Access Audit Site Report

Lake Mineral Wells State Park and Trailway

Accessibility Evaluation

Inspection Date: 07/12/2021

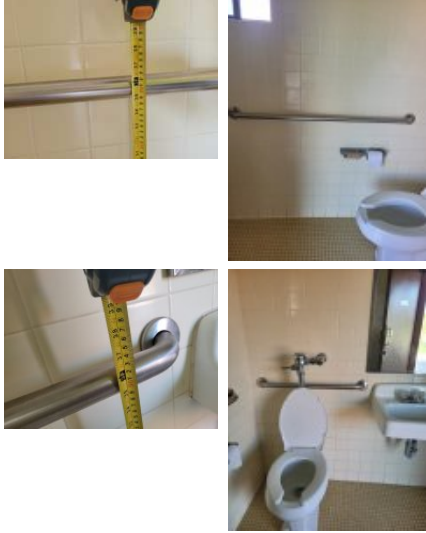
11	Headquarters : Headquarters	[32.8126, -98.04362]	There are no accessible parking stalls. Each lot where parking is provided for the public as clients, guests or employees, shall provide accessible parking and shall be located on the shortest accessible route of travel from adjacent parking to an accessible entrance. There are a total of 11 parking stalls in the parking lot that could be reasonably associated with this facility. There should be a minimum of 1 accessible stalls with a minimum of 1 being designed as van accessible.	HQ offices- 11 standard stalls, 0 accessible stalls	Create one or more 8' accessible parking stalls, with one 5' adjacent access aisle, with proper signage and striping based on the total number of stalls	2015 ABAAS Section: F208.2 2012 TAS Section: 208.2 2010 ADAS Section: 208.2		
12	Headquarters : Headquarters	[32.8126, -98.04362]	Element meets all standards and requirements	Registration entry - door complies	None	2010 ADAS Section: N/A

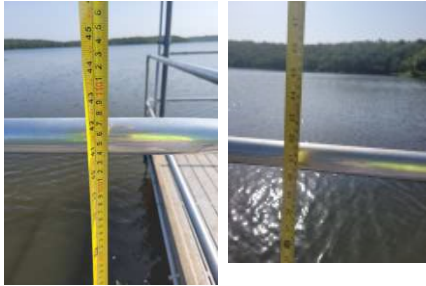
Finding Number	Area Description	Lat/Long	Finding	As Built	Recommendation	Citation	Photos	Figure
54	Day Use Area: Swimming/Boat Ramp/Concession Area	[32.8145465 , -98.0386807]	The cross slopes (narrow dimension) and/or running slopes (long dimension) of the access aisle exceeds 2%. The running slope and the cross slope in an accessible parking stall and the access aisle must not exceed 2%.	Store: stall 6.5%, AA 8%, Restroom- stall 3%, 4.4% in AA	Repair or correct slope of parking space and access aisle to max 2.08% in any direction	2015 ABAAS Section: 502.4 2012 TAS Section: 502.4 2010 ADAS Section: 502.4

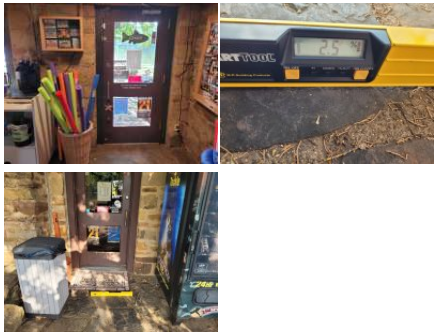
Finding Number	Area Description	Lat/Long	Finding	As Built	Recommendation	Citation	Photos	Figure
81	Day Use Area: Day Use	[32.8153051 , -98.032585 4]	The parking sign is mounted too low. Parking space identification signs shall include the International Symbol of Accessibility complying with. Signs identifying van parking spaces shall contain the designation "van accessible." Signs shall be 60 inches minimum above the finish floor or ground surface measured to the bottom of the sign.	Day Use 2 - 56.75", day Use 1 - 57"	Raise existing accessible parking signs so lowest end of bottom sign is min 60" aff	2015 ABAAS Section: 502.6 2012 TAS Section: 502.6 2010 ADAS Section: 502.6		
82	Day Use Area: Day Use	[32.8154584 , -98.032842 9]	The surface of trails, passing spaces, and resting intervals shall be firm and stable	trail from day use not accessible	Replace surface of trail with one that is firm and stable as a smart practice.	2015 ABAAS Section: 1017.2

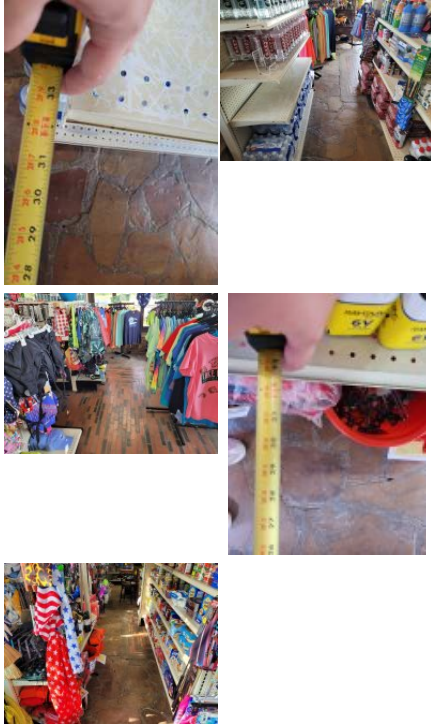
90	Day Use Area: Park Store	[32.8147212 , -98.038695 5]	Exterior doors exceed 8.5 lbs of force to open; fire doors shall have a minimum opening force allowable by the appropriate administrative authority	store entry from parking- 16#	Inspect, adjust, and maintain 8.5 lbf to open exterior doors as a smart practice	2010 ADAS Section: 404.2.9		
91	Day Use Area: Park Store	[32.8147348 , -98.038703 5]	The handrail gripping diameter is noncompliant. Handrail gripping surfaces with a circular cross section shall have an outside diameter of 1 1/4 inches minimum and 2 inches maximum. Handrail gripping surfaces with a non-circular cross section shall have a perimeter dimension of 4 inches minimum and 6 1/4 inches maximum, and a cross-section dimension of 2 1/4 inches maximum.	park store stairs- handrails too large	Install handrails on both sides of stairway, mounted 34" to 38" aff with top and bottom extensions and having a 1.25" – 2" in diameter, or a non-circular grip that has a perimeter dimension of 4"- 6.25" max with a min gap of 1.5" between handrail and wall	2015 ABAAS Section: 505.7 2012 TAS Section: 505.7 2010 ADAS Section: 505.7

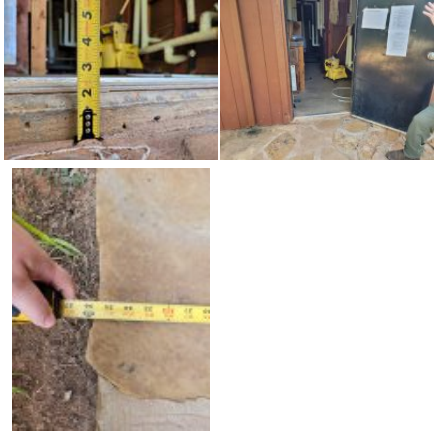
107	Day Use Area: Day Use 1 - Men's Restroom	[32.8126, -98.04362]	There are not enough accessible toilet compartments. A minimum of 1 must be wheelchair accessible .	ambulatory only	Create a wheelchair accessible stall with grab bars and fixtures mounted in correct locations and at correct heights	2015 ABAAS Section: F213.3.1 2012 TAS Section: 213.3.1 2010 ADAS Section: 213.3.1

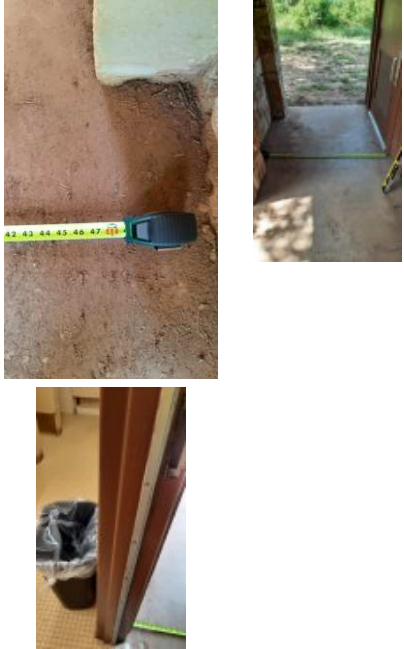
115	Day Use Area: Day Use 1 - Women's Restroom	[32.81528, -98.03297]	The restroom sign does not comply with one or more applicable requirements for the location, height, and properties of the sign.	sign lacks Braille and raised characters	Acquire and mount signage, including Braille and access symbol mounted on wall, latch side of door, 48" to baseline of lowest character and 60" to baseline of highest character	2015 ABAAS Section: F216.2, 703.1, 703.2, 703.5, 703.6 2012 TAS Section: 216.2, 703.1, 703.2, 703.5, 703.6 2010 ADAS Section: 216.2, 703.1, 703.2, 703.5, 703.6

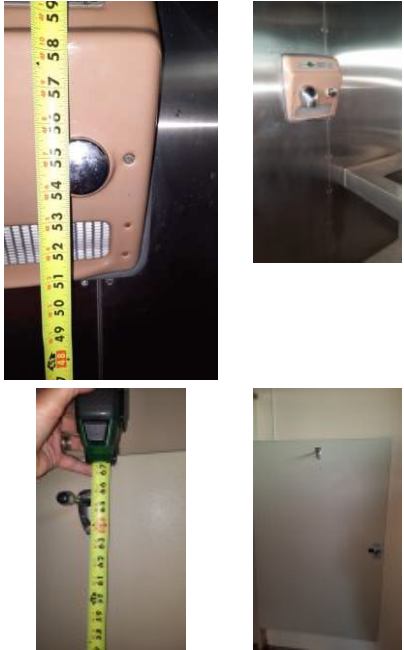
Finding Number	Area Description	Lat/Long	Finding	As Built	Recommendation	Citation	Photos	Figure
182	Trails: Cold Springs trailhead	[32.824318, -97.895031]	The restroom sign does not comply with one or more applicable requirements for the location, height, and properties of the sign.	restroom lacks signage	Acquire and mount signage, including Braille and access symbol mounted on wall, latch side of door, 48" to baseline of lowest character and 60" to baseline of highest character	2015 ABAAS Section: F216.2, 703.1, 703.2, 703.5, 703.6 2012 TAS Section: 216.2, 703.1, 703.2, 703.5, 703.6 2010 ADAS Section: 216.2, 703.1, 703.2, 703.5, 703.6		
183	Trails: Cold Springs trailhead	[32.8243259, -97.8950229]	The side grab bars are not in the correct location. Grab bars on the side wall must be installed so that the end closest to the rear wall is maximum 12" from the rear wall. The end furthest from the rear wall must be mounted minimum 54" from the rear wall.	side bar extends 46" to end	Remount side grab bar to max 12" from the rear wall at the close end and min 54" on the far end, and 33" to 36" aff	2015 ABAAS Section: 604.5.1 2012 TAS Section: 604.5.1 2010 ADAS Section: 604.5.1

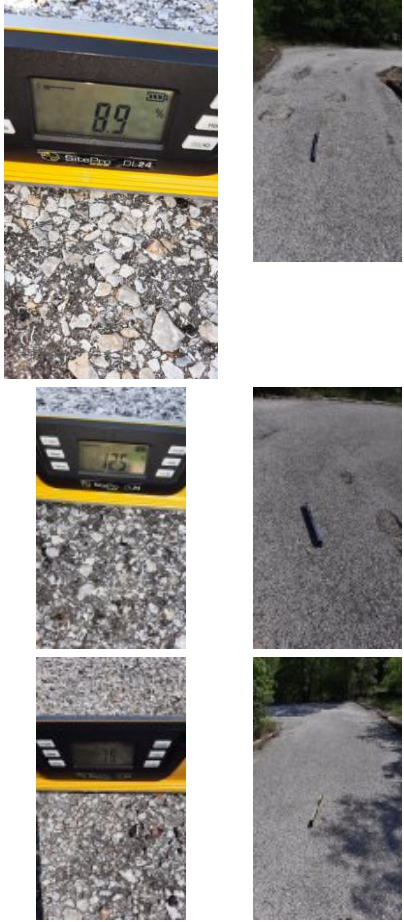
217	Trails: Amphitheater Trailhead	[32.8135952 , -98.031485 7]	Element meets all standards and requirements	W/M RR - door complies	None	2010 ADAS Section: N/A		
218	Trails: Amphitheater Trailhead	[32.8135952 , -98.031792 8]	Element meets all standards and requirements	parking scoping complies- 92/4, 10RV	None	2010 ADAS Section: N/A		
219	Trails: Amphitheater Trailhead	[32.8135829 , -98.031778]	The access aisle is missing at the accessible parking stall. Access aisles serving parking spaces shall adjoin an accessible route. Two parking spaces shall be permitted to share a common access aisle.	lack designated aisle, but all stalls are 14' wide	Create one or more 8' accessible parking stalls, with one 5' adjacent access aisle, with proper signage and striping	2015 ABAAS Section: 502.3.1 2012 TAS Section: 502.3.1 2010 ADAS Section: 502.3.1

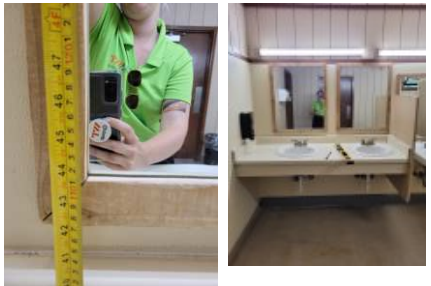
285	Camping: Post Oak Camping Area	[32.8208231 , -98.0378264]	The accessible path of travel between the building entrance and the accessible parking contains cross slopes greater than 2%. Surface cross slopes shall not exceed one unit vertical in 48 units horizontal (2-percent slope). When the slope in the direction of travel of any walk exceeds 1 unit vertical in 20 units horizontal (5-percent slope), it must be constructed as ramp.	2.2% cross in center of path to restroom building	Correct or repair sidewalk cross slope along AR to max 2.08%	2015 ABAAS Section: 403.3 2012 TAS Section: 403.3 2010 ADAS Section: 403.3		
286	Camping: Post Oak Camping Area	[32.8207972 , -98.0378358]	The running slope of walking surfaces shall not be steeper than 1:20.	9.4% slope in center walk way	Correct running slope along the AR to max 5%	2015 ABAAS Section: 403.3 2012 TAS Section: 403.3 2010 ADAS Section: 403.3

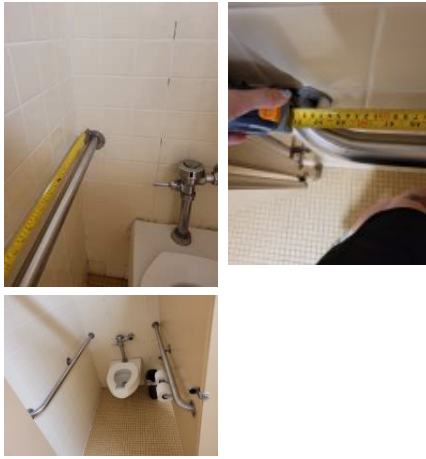
301	Camping: Live Oak Camping Area	[32.8126, -98.04362]	There are not enough accessible toilet compartments. A minimum of 1 must be wheelchair accessible .	big oak women's restroom- lacks wheelchair compartment	Create a wheelchair accessible stall with grab bars and fixtures mounted in correct locations and at correct heights	2015 ABAAS Section: F213.3.1 2012 TAS Section: 213.3.1 2010 ADAS Section: 213.3.1

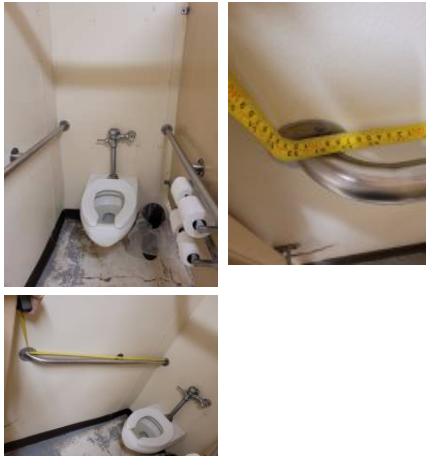
373	Camping: Live Oak Camping Area	[32.8126, -98.04362]	Element meets all standards and requirements	dumping station complies	None	2010 ADAS Section: N/A

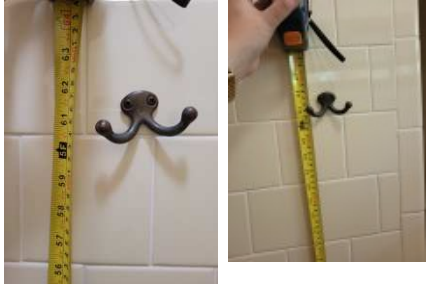
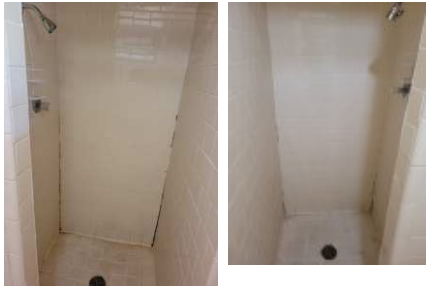
428	Camping: Plateau Camping Area	[32.8126, -98.04362]	30 inches (760 mm) by 60 inches (1525 mm) with the long side of the space adjoining or overlapping an accessible parking space or pull-up space for recreational vehicles. Locate the space so that the hook-ups are at the rear center of the space. Bollards or other barriers shall not obstruct the clear ground space in front of the hook-ups	site 86- lacks CGS at utilities	Provide required 30" by 60" clear ground space with hook ups at the rear of the space as a smart practice	2015 ABAAS Section: 1011.2		
429	Camping: Plateau Camping Area	[32.8126, -98.04362]	Water spouts at water hydrants and water utility hook-ups shall be 28 inches (710 mm) minimum and 36 inches (915 mm) maximum above the ground	site 86- 28" aff utility	Remount water spouts to 28" min or 36" max above the ground as a smart practice	2015 ABAAS Section: 1011.6

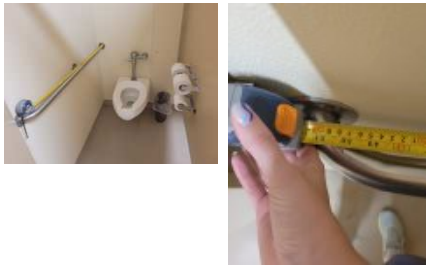
469	Camping: Plateau Camping Area	[32.8262395 , -98.034559 5]	There are no van accessible parking stalls. 1 in every 6, minimum of one, required accessible stalls must be a van accessible stall.	bath house- lacks designated van space	Add van parking sign to one accessible stall and repaint stall and access aisle to 11' and 5' or 8' and 8' per the table	2015 ABAAS Section: F208.2, F208.2.4 2012 TAS Section: 208.2, 208.2.4 2010 ADAS Section: 208.2, 208.2.4

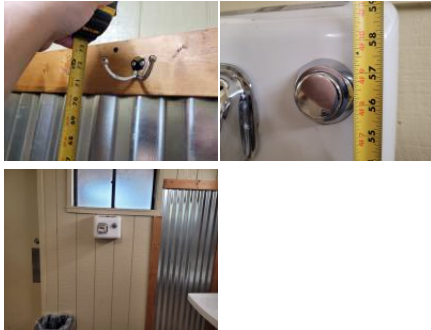
540	Group Hall: Group Hall - Women's Restroom	[32.81941, -98.04166]	There are not enough accessible toilet compartments. The room contains toilet compartments. A minimum of 1 must be wheelchair accessible .	no wheelchair accessible stall	Create a wheelchair accessible stall with grab bars and fixtures mounted in correct locations and at correct heights.	2015 ABAAS Section: F213.3.1 2012 TAS Section: 213.3.1 2010 ADAS Section: 213.3.1

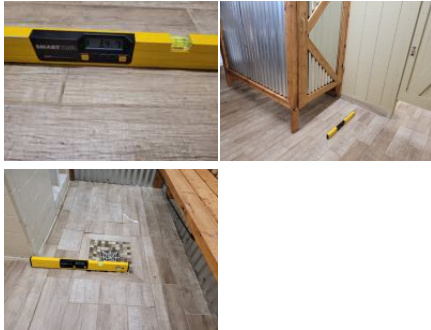
548	Group Hall: Group Hall - Women's Restroom	[32.81926, -98.0417]	There are no accessible bathing or shower facilities. Where facilities for bathing are provided for the public, clients or employees, including showers or bathtubs, at least one shower or bathtub and support facilities such as lockers, and not less than 1 percent of all facilities, shall be accessible.	lacks accessible shower	Create an accessible shower in locker/bathing room	2015 ABAAS Section: F213.3.6 2012 TAS Section: 213.3.6 2010 ADAS Section: 213.3.6

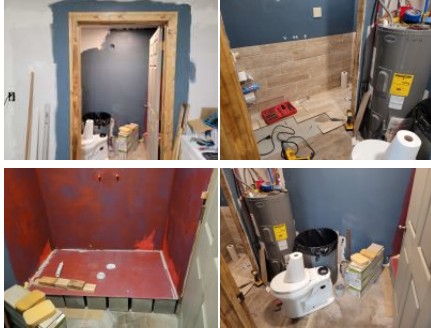
554	Group Hall: Group Hall - Men's Restroom	[32.81942, -98.04173]	There are not enough accessible toilet compartments. The room contains toilet compartments. A minimum of 1 must be wheelchair accessible .	ambulatory stall only	Create a wheelchair accessible stall with grab bars and fixtures mounted in correct locations and at correct heights.	2015 ABAAS Section: F213.3.1 2012 TAS Section: 213.3.1 2010 ADAS Section: 213.3.1
